Elevation Plans_V1.pdf Markup Summary

6/27/2022 9:39:02 PM (1)

1 FRONT ELEVATION (NORTH-WEST)
 SCALE: 3/16" = 1'-0"

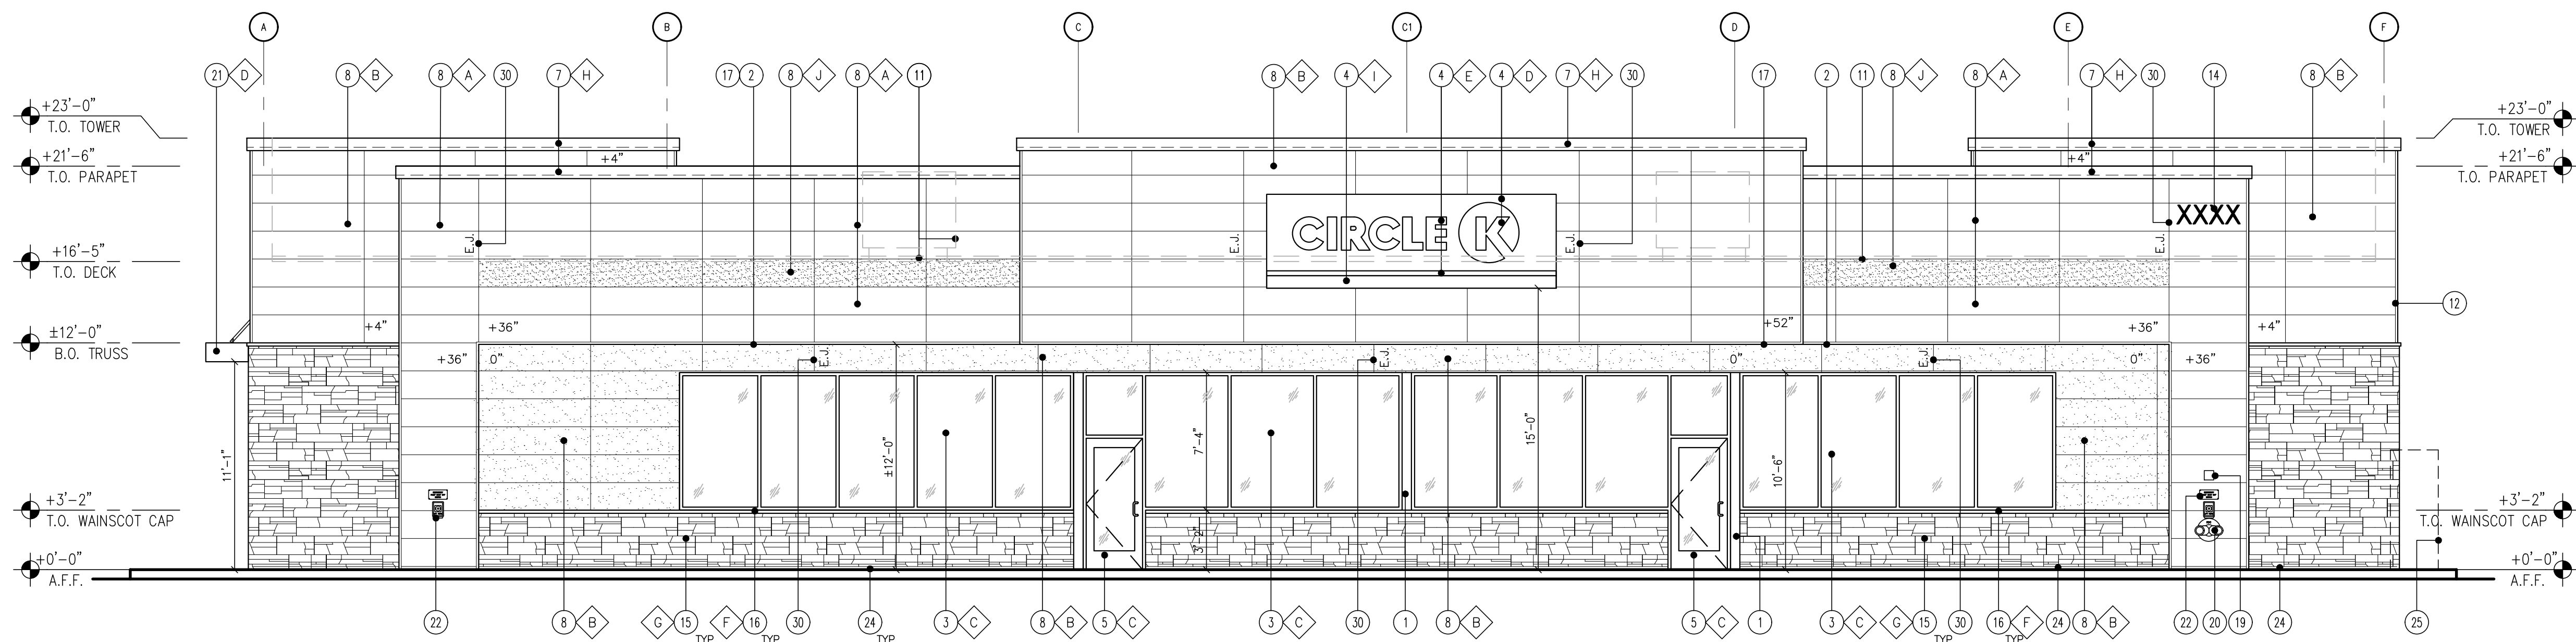
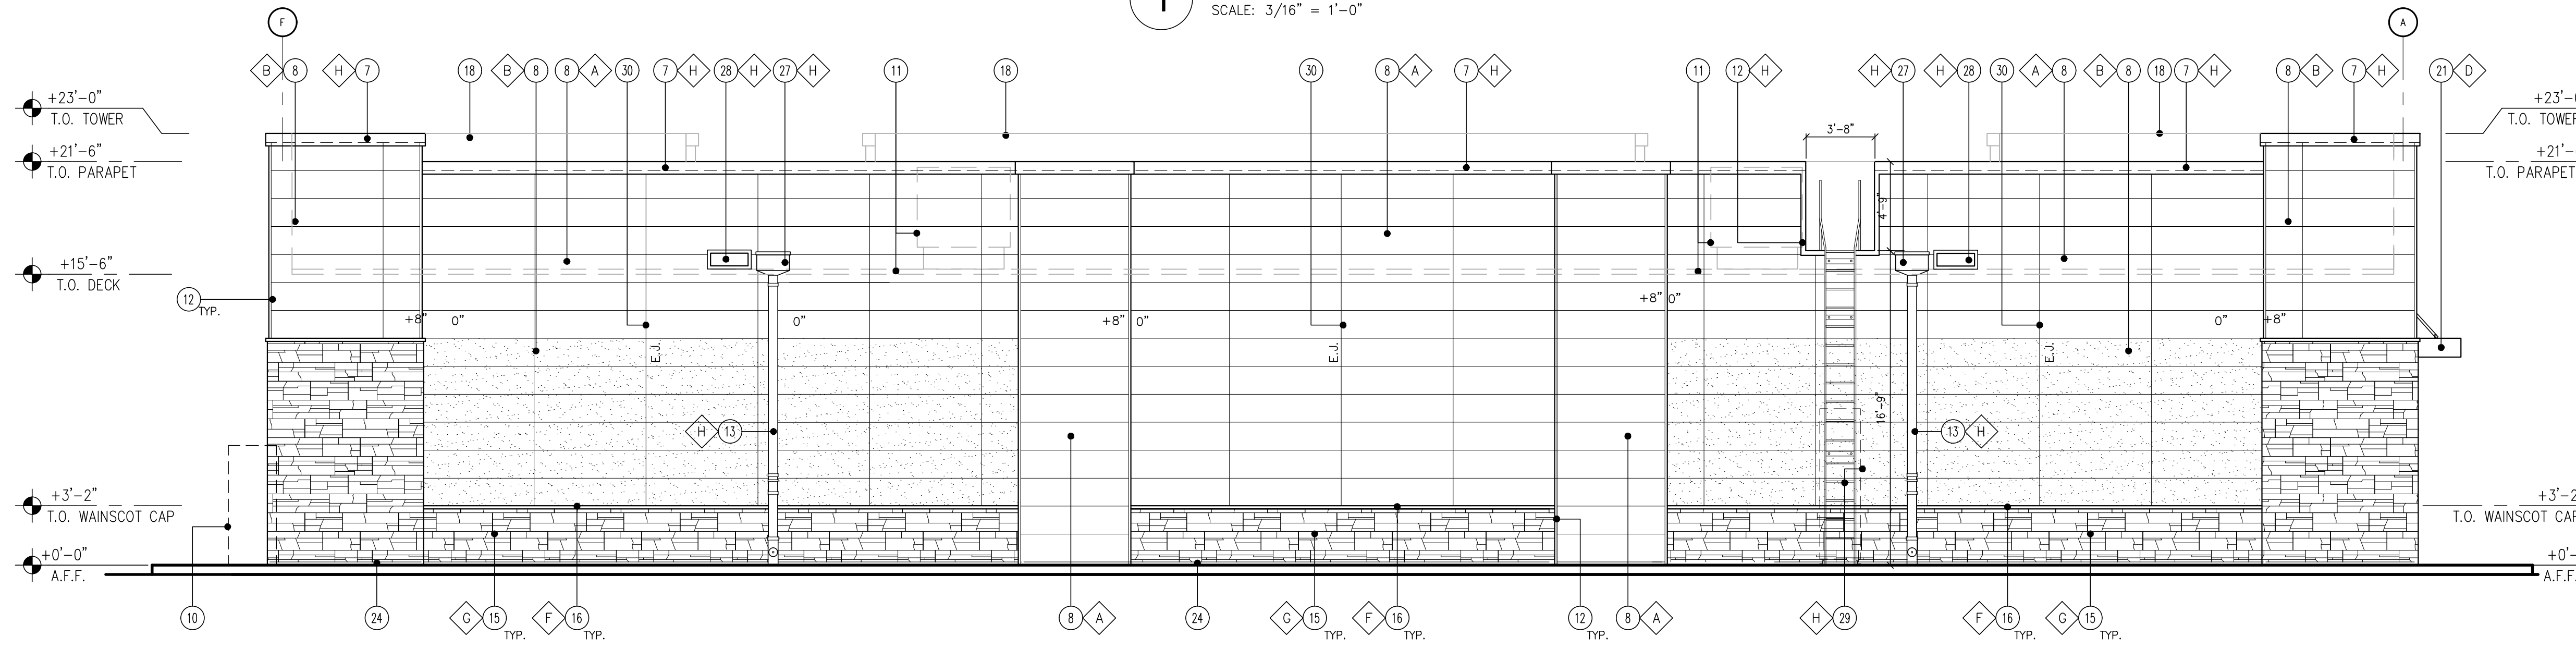
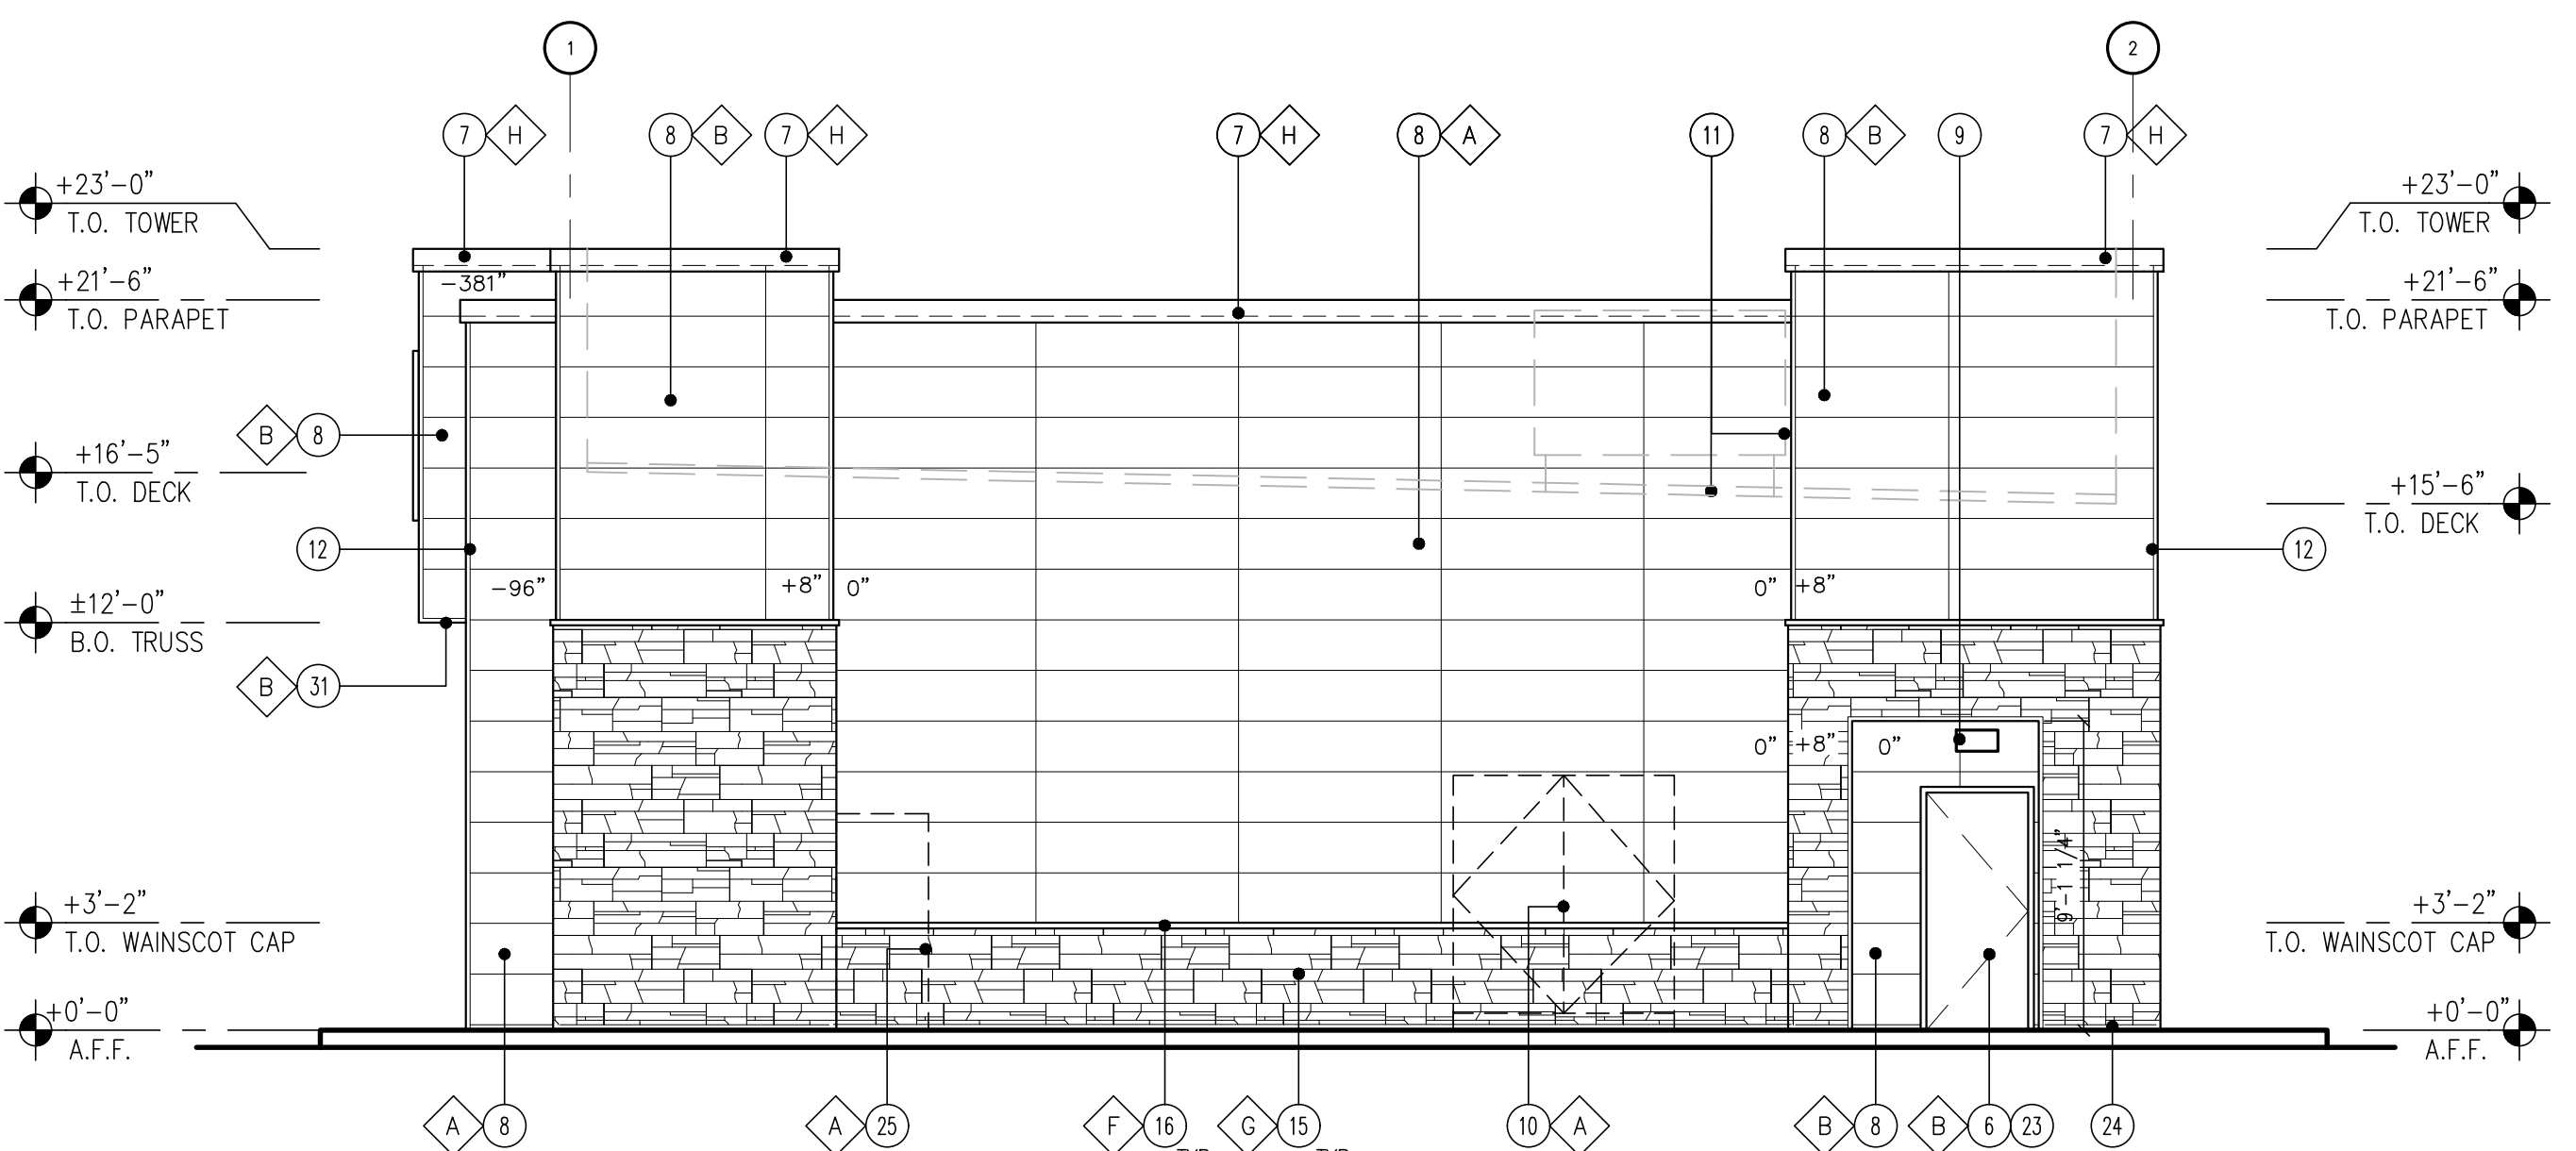
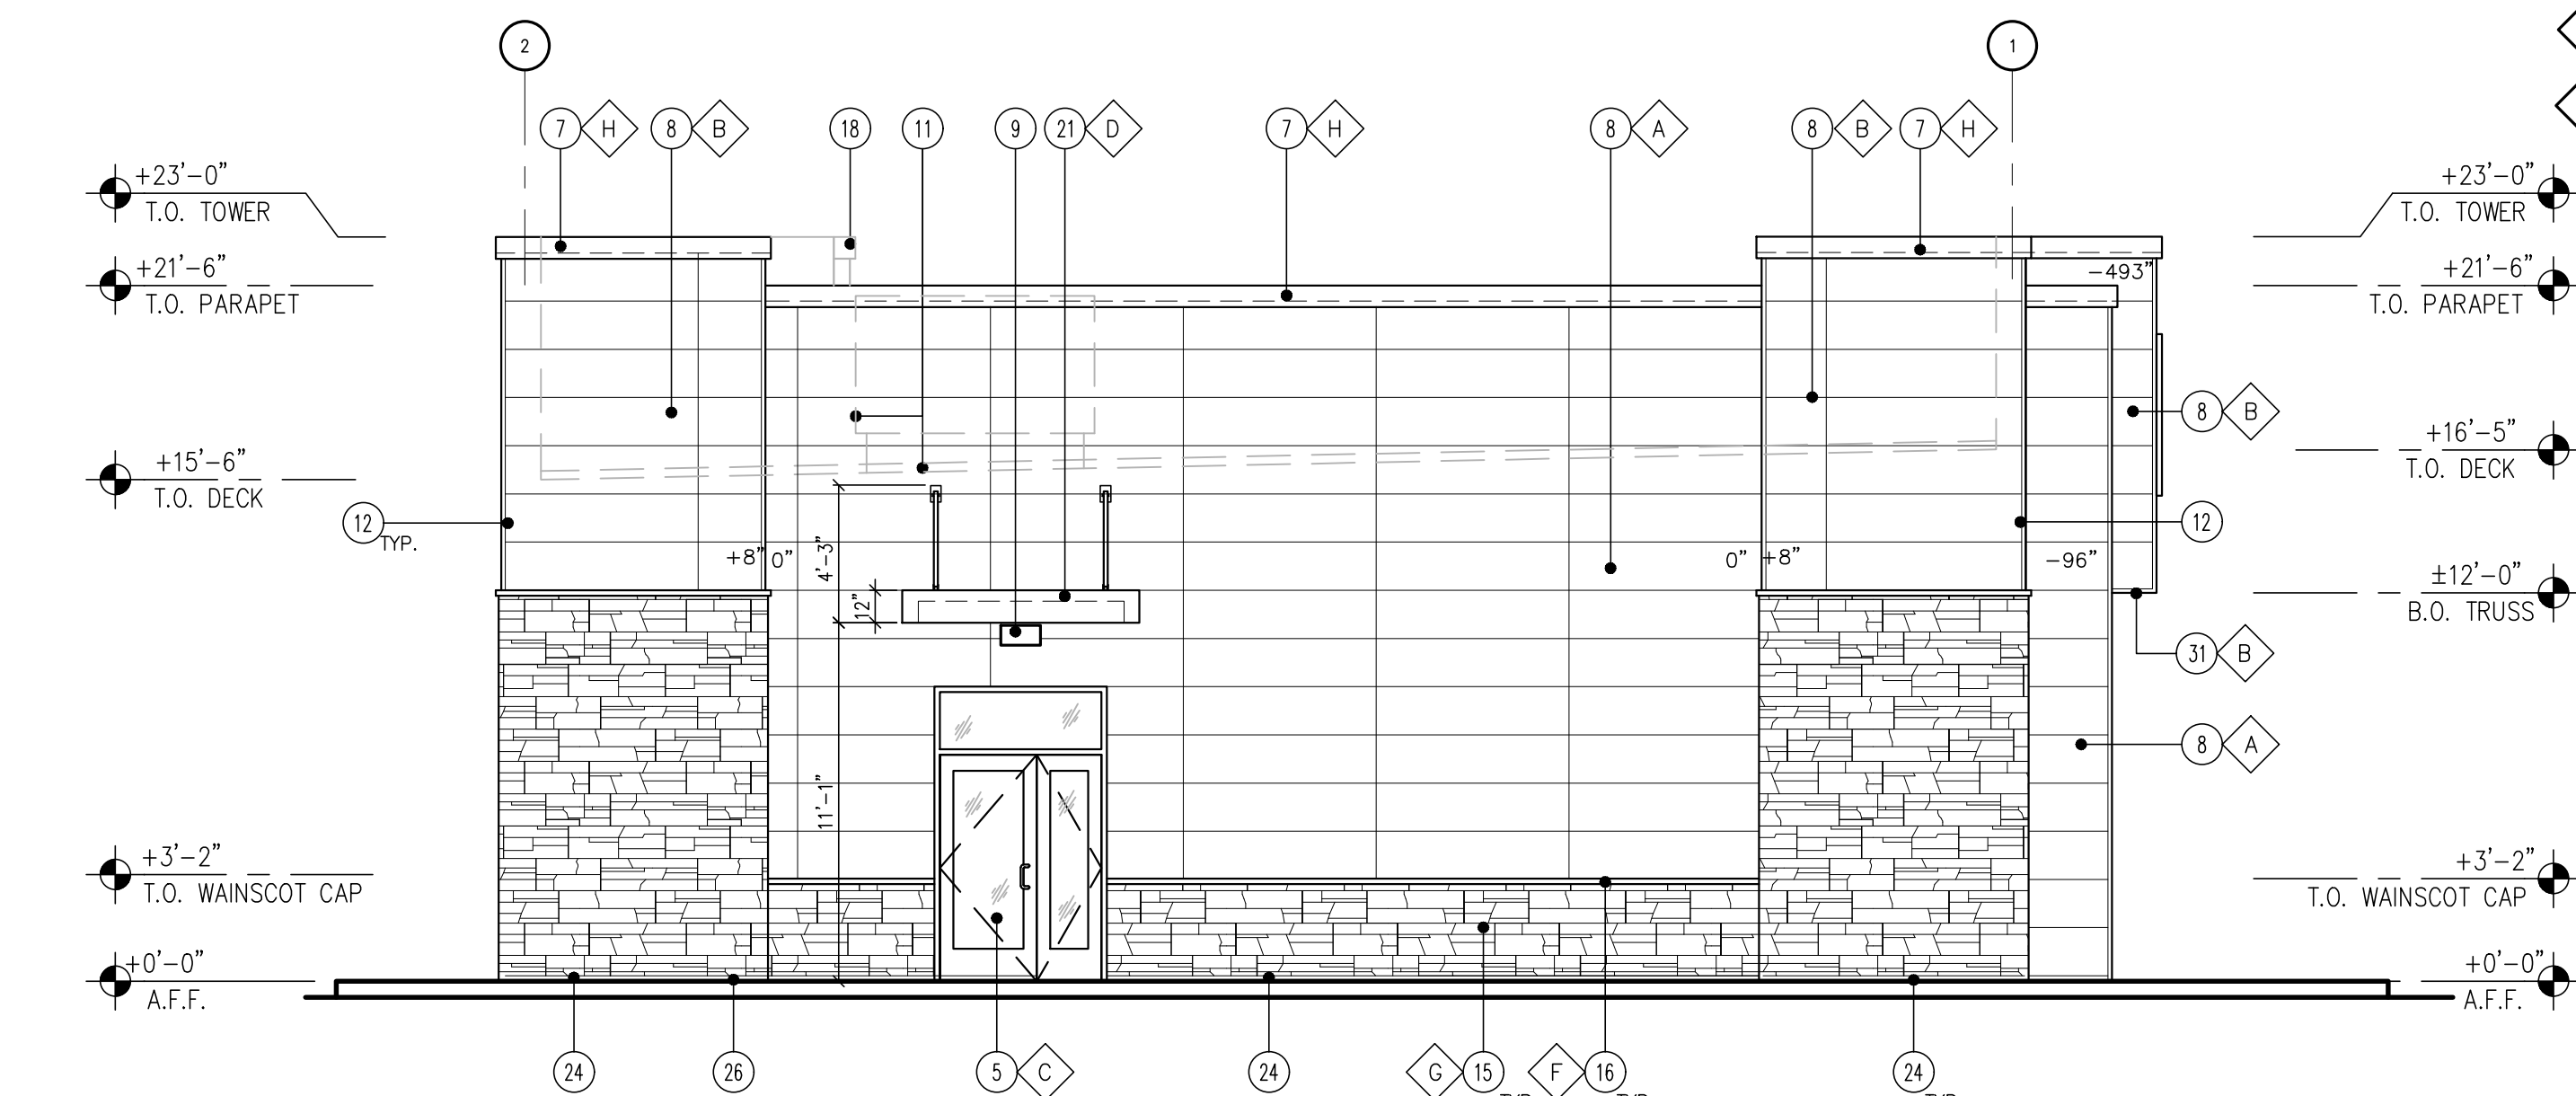
Include Signature block for the Planning and Community Development Director a minimum of 1 inch by 2 inch.

Include Signature block for the Planning and Community Development Director a minimum of 1 inch by 2 inch.
